CONNECTICUT COASTAL MANAGEMENT MANUAL

SECTION 4

SITE PLAN EXAMPLES

RESIDENTIAL SUBDIVISION

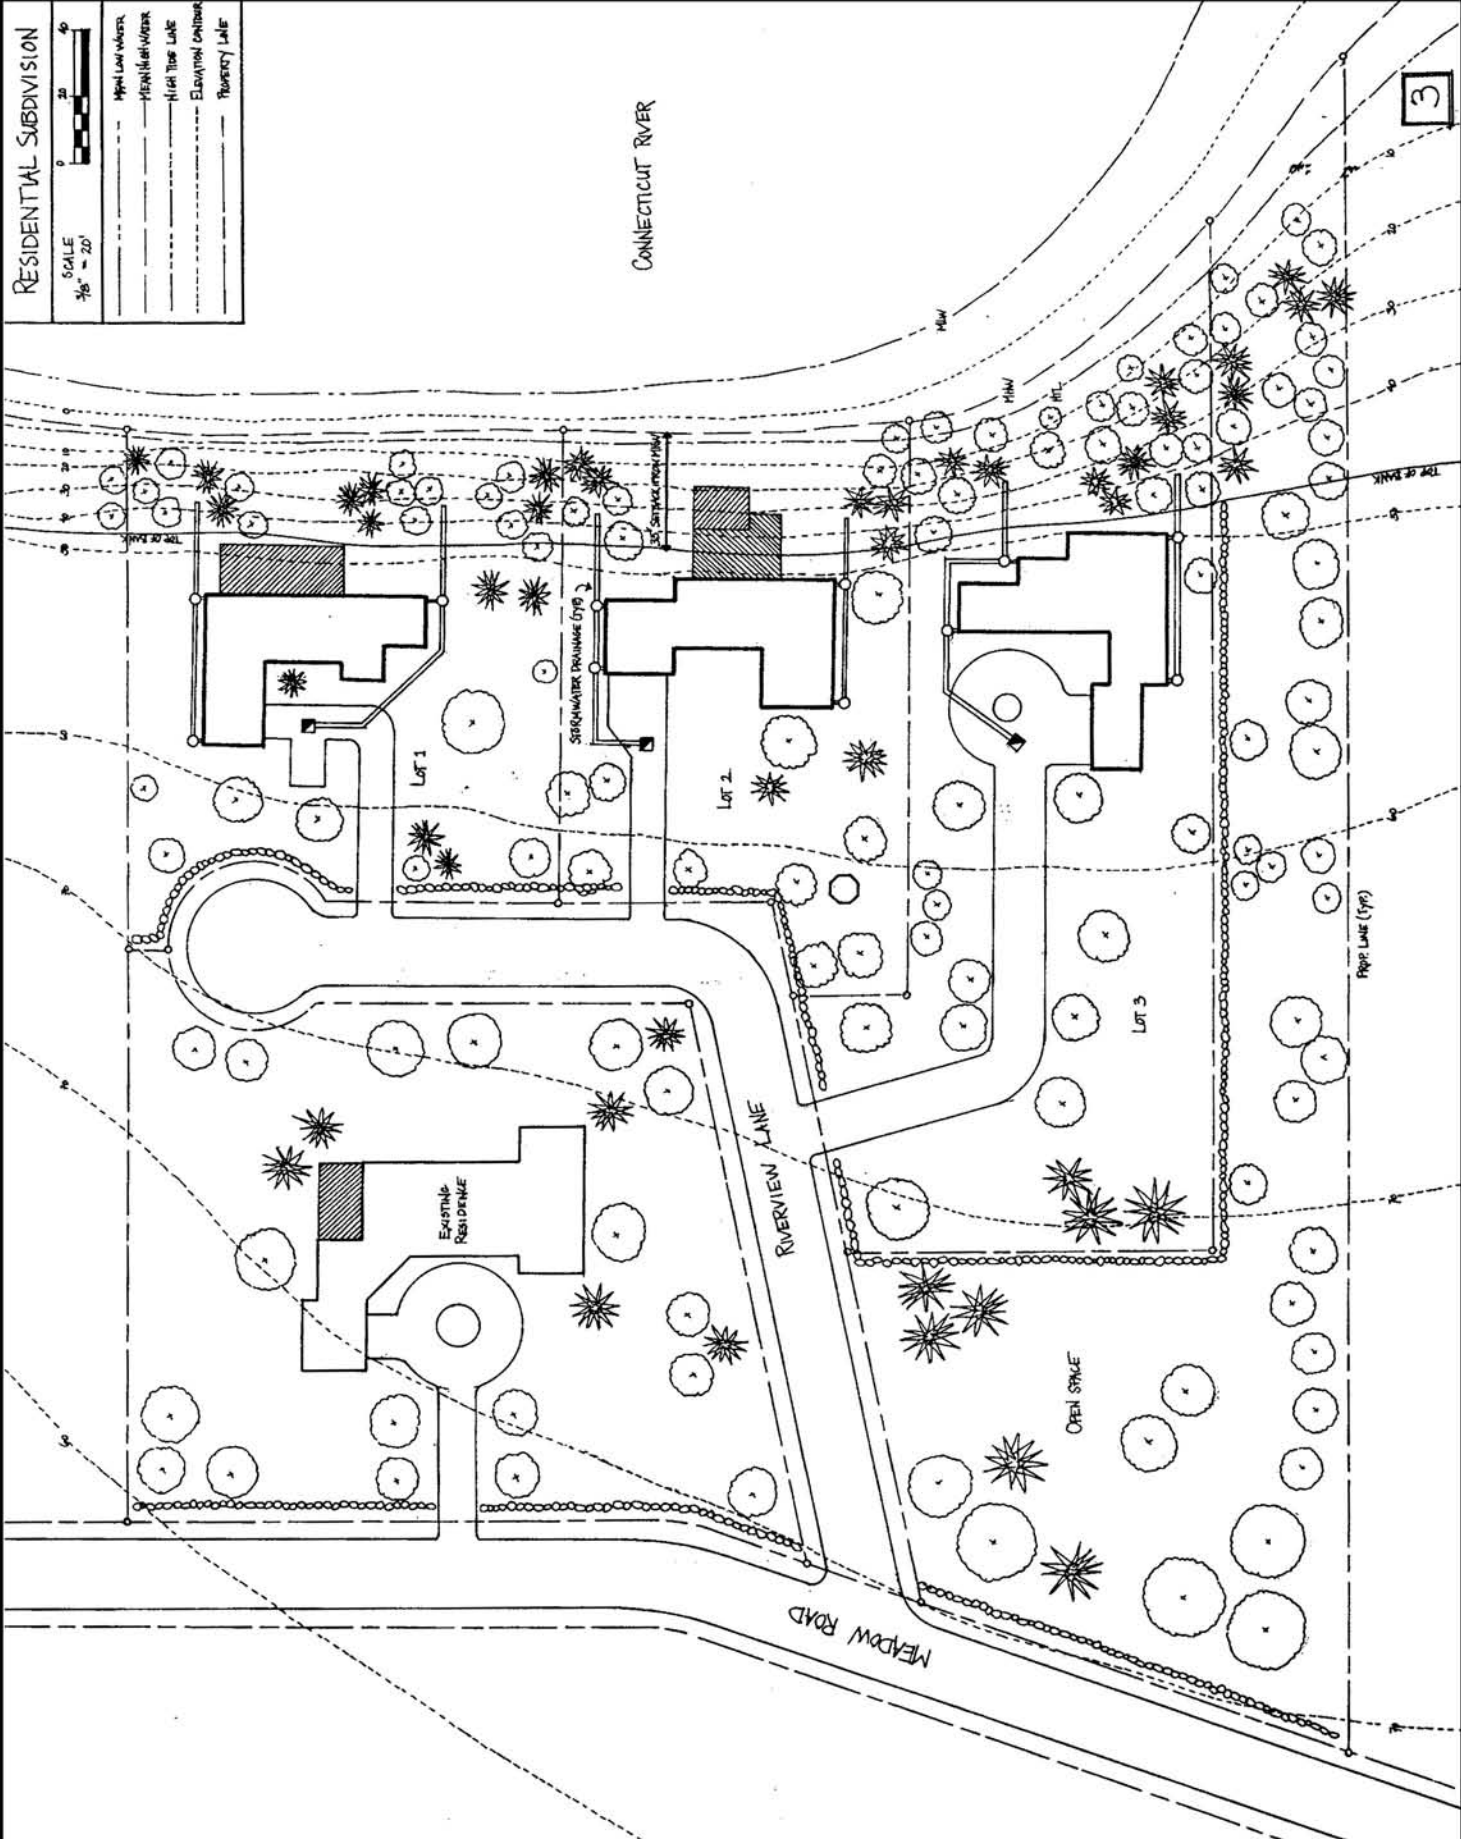
- 1) No vertical datum shown (plans should reference NGVD 1929)
- 2) Incomplete listing of coastal resources (coastal bluff/escarpment not indicated on plan).

- 1) Potential accelerated erosion of coastal bluff and escarpment and future erosion threats to inhabited structures
- 2) Potential adverse impacts to coastal water quality from accelerated bluff erosion and untreated stormwater runoff.
- 3) No water-dependent use at a waterfront site.
- 4) Degraded views and vista of bluff from the river opposite river bank.

The Connecticut Coastal Management Act (CCMA) policy for managing coastal bluffs and escarpments is to preserve their toe and slope, discourage uses which modify natural rates of erosion, and disapprove uses that accelerate slope erosion and alter supply of sediments to the littoral transport system. A related CCMA coastal hazard area policy also applies. It requires that proposed development in these areas be allowed only upon a demonstration that coastal flood and erosion hazards are minimized and that only non-structural methods to control these hazards be allowed for construction permitted after January 1, 1980, the effective date of the CCMA. In order to better understand how these policies apply to a specific location, the board or commission should direct staff to determine if an erosion study of the local shoreline exists. The Connecticut Coastal Management Program funded studies of erosion along Connecticut's coast during the 1980's. These studies including maps and periodic aerial surveys can be used to determine how an area of the coast responds to coastal erosion and depositional processes. This information, along with any additional information the commission or board can require from the applicant, should be used to apply these policies to the coastal site plan under review.

All three proposed dwelling units would likely increase erosion of the site's bluff/escarpment and increase hazards to life and property. Stormwater is proposed to directly discharge over the face of the bluff on all three proposed lots, subjecting the bluff to accelerated erosion forces. Further, the deck proposed on lot #2 would encroach waterward of the top of bank of the bluff modifying the face of the bluff that could destabilize the bluff in this area. These site modifications, along with siting the proposed structures proximate to the top of the face of the bluff, would likely also imperil the proposed structures over time. Once the structures become threatened by erosion of the bluff, the homeowners would likely proposed flood and erosion control structures, which is inconsistent with CCMA policy, as described above.

Views of the undisturbed bluff from the river and opposite bank of the river may be altered by clearing vegetation from the bluff and construction of the proposed houses. The relevant CCMA policy is contained within the minimization of "adverse impacts on coastal resources" policy, which includes but are not limited to... (F) degrading visual quality through the significant alteration of the natural features of vistas and view points (CGS Sec. 22a-93(15)). Within this context, this policy recognizes the importance of the visual quality of the **natural resources** of the coastline and the visual access to them. We understand that these policies are general in nature and, therefore, difficult to implement without subjective interpretation. Vistas and view points have traditionally been interpreted by DEP-OLISP to mean "public" views of the coastline and coastal resources. They have not been interpreted to mean "personal or private" views. As such, they have not been applied as a means of protecting "personal or private" views but public views. For example, the policies were not intended to prevent obstruction of private views or view corridors of coastal resources. As such, a private waterfront development should not be considered to be an obstruction of any other private view.

Relocate the proposed structures landward toward Meadow Road and modify the stormwater drainage plan to eliminate direct discharge to the bluff. Such a site redesign, which would require realignment of the proposed Riverview Lane, driveways and lot dimensions, would minimize impervious cover, thereby reducing stormwater runoff, allowing stormwater to drain across a vegetated buffer between the relocated houses and the top of the bluff's bank and reducing the erosive force of stormwater runoff. A modified site design which maximizes building setback from the top of bank would also minimize potential future erosion hazards to these structures thereby reducing the potential for future structural flood and erosion

control structures. The board or commission may wish to modify its setback requirements for areas with coastal bluffs and escarpments if setbacks in these areas are determined using distances measured from mean high water rather than the top of the bluff's bank. As evident in this development scenario, the appropriate reference point from which to measure a shoreline setback is from top of bank, not mean high water, to protect coastal bluffs/escarpments (and water quality).

The additional undeveloped area created by setting the structures further back from the top of bank could be used to treat stormwater runoff as well as reduce erosive velocities. This area could be used to support drywells or swales from which stormwater could "leak-off" as sheet flow toward the bluff. Riverview Lane could be constructed without curbs to allow stormwater runoff from this road as sheet flow into roadside swales for on-site infiltration.

A site redesign, as described above, would also better accommodate a water-dependent use at the site-specifically, coastal public access (the only appropriate water-dependent use for this site). A coastal public access area would likely be best accommodated in the open space area adjacent to lot #3. The coastal public access open space area should include two or three parking spaces off Meadow Road, if on-street parking is not allowed. A clearly defined path from the road/parking, with public access signs at street/path connection, to the shoreline should be provided. Some type amenities should be provided at the top of the bank at the end of the coastal public access path (bench with bollards) which clearly defines the extent and terminus of the access area.

COMMERCIAL DEVELOPMENT

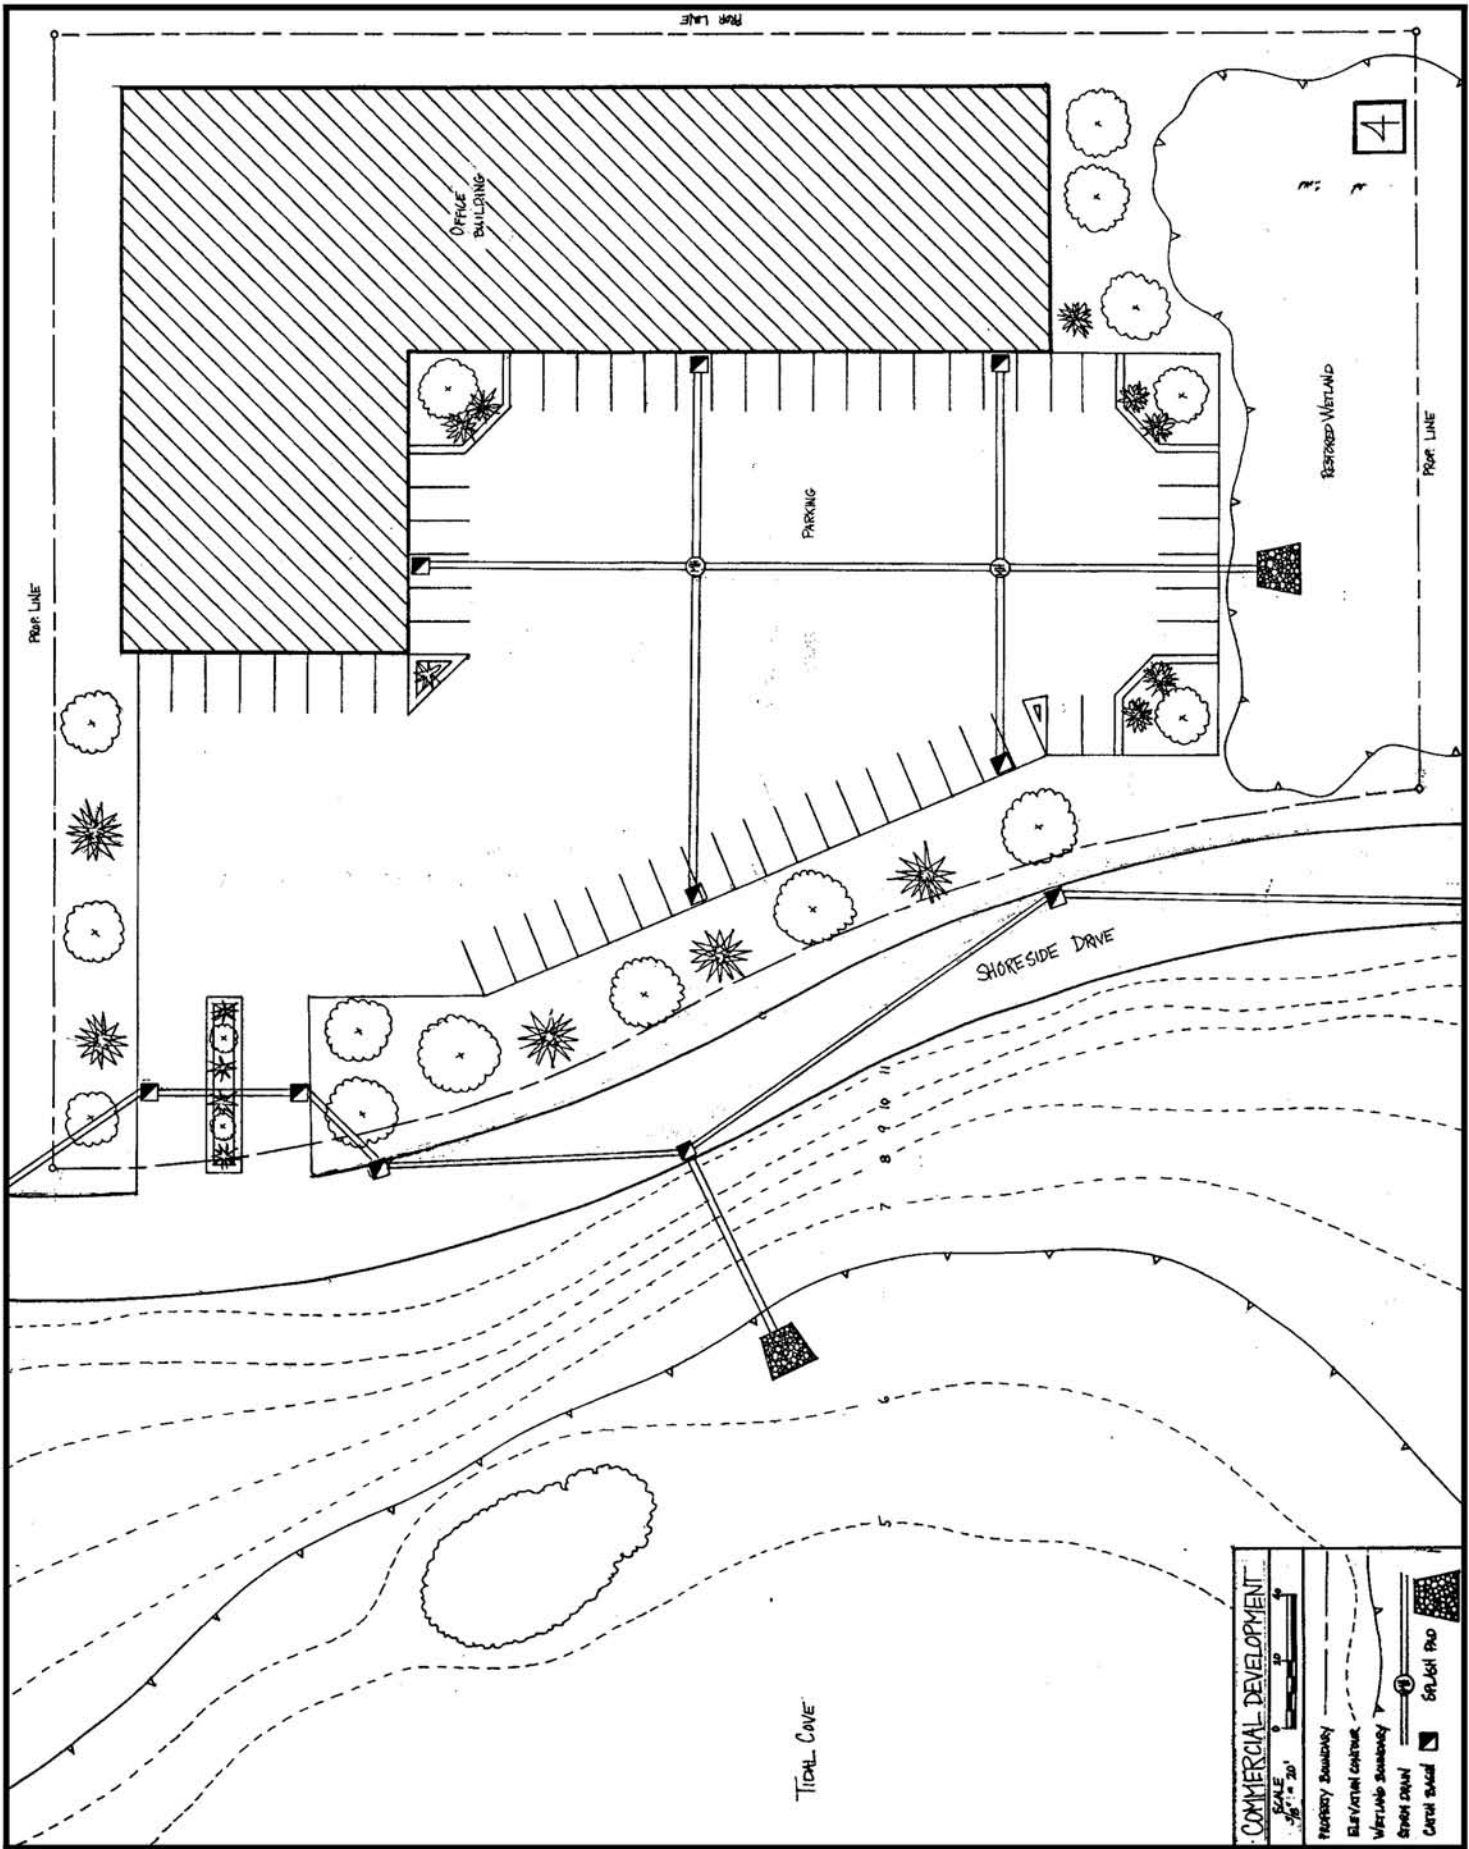
- 1) Tidal datums (i.e., mean high water and the high tide line) and vertical datum (NGVD 1929) not shown.
- 2) “Wetlands” label does not indicate whether wetlands are tidal wetlands or inland wetlands.
- 3) No elevation contours shown upland of elevation 11.
- 4) Flood hazard areas (if present) not delineated.
- 5) Direction of stormwater flow not shown (optional, but helpful).
- 6) Coastal resources are not identified on site plan (shorelands, flood hazard areas, tidal wetlands, inland wetlands, coastal waters)

- 1) Stormwater management system does not minimize development’s potential adverse impacts to coastal water quality - no stormwater best management practices (BMPs) proposed.
- 2) Restored tidal wetland/inland wetlands adversely affected by stormwater discharges and discharge structures
- 3) If building is in a flood hazard area, building must be elevated or flood-proofed.
- 4) State coastal permits required for fill/stormwater discharge structures in tidal wetlands or areas below the high tide line.

The stormwater drainage plan is unacceptable. To correct the problem, stormwater BMPs should be incorporated into the proposal. The first step in this process is to identify the potential pollutants in stormwater runoff at the site (see *Stormwater Management* fact sheet for description of parking lot runoff pollutants) and estimate the quantity of runoff generated by the “first-flush” of runoff generated by a 1 inch rainfall event. Next, the appropriate stormwater BMPs should be selected based upon the targeted pollutants, quantity of flow, and site conditions (e.g., soils, slope, available land area, etc.). To the extent possible, non-structural and low maintenance methods (e.g., vegetated swales) for treating stormwater that infiltrates runoff into on-site soils should be used. If necessary, structural methods (e.g., oil and gross particle separators) may be used, ideally in tandem with non-structural methods, if site conditions limit use of non-structural methods. It is particularly important that applicants be made aware that they may need to redesign a proposed development to accommodate non-structural stormwater management methods if insufficient space is provided on the coastal site plan submitted for review.

- *No* direct discharges to tidal wetlands should be allowed. Since runoff from the roof of the proposed building is cleaner than that from the parking lot, these sources of runoff should be separated and treated differently. Roof runoff can be discharged to a vegetated swale designed to enhance infiltration into the soil. Parking lot runoff can be treated using a variety of BMPs. Often BMPs used in series are the most effective. For example, surface drains containing adsorbent material to capture hydrocarbons could be used, as can modified catch basins with deep sumps and hooded outlets, to capture pollutants early in the stormwater conveyance system. Then, the stormwater could drain through a level spreader and over a vegetated buffer prior to discharge to the restored wetland. Alternatively, dry creeks could be installed adjacent to the parking lot. Again, water passing through the creeks could flow over the vegetated buffer on its way to inland wetlands. For parking lots with islands, dry creeks can be incorporated into the islands. It may be necessary to require the applicant

to eliminate proposed parking spaces to make an area available to accommodate the swales and dry creeks.

- Prior to the selection of stormwater BMPs, site design should first consider designing the building around significant trees and existing topography. Trees that overhang parking areas intercept rainfall, provide shade for the pavement (and vehicles), and transpire large quantities of water back to the atmosphere between rainfall events.

- Another potential solution could be to use infiltration galleries located below the parking surface. However, suitable soil condition *must* exist and pretreatment of stormwater prior to it entering the galleries to remove litter, suspended solids, and hydrocarbons is required.

- Other potential solutions might include the use of catch basin insert technology, depression storage, curbless parking areas with infiltration trenches, and drywells.

- Please note that maintenance of the stormwater management system is critical to its effectiveness. Stormwater management plans should include a scheduled maintenance plan with a dedicated funding source to ensure that periodic maintenance is performed.
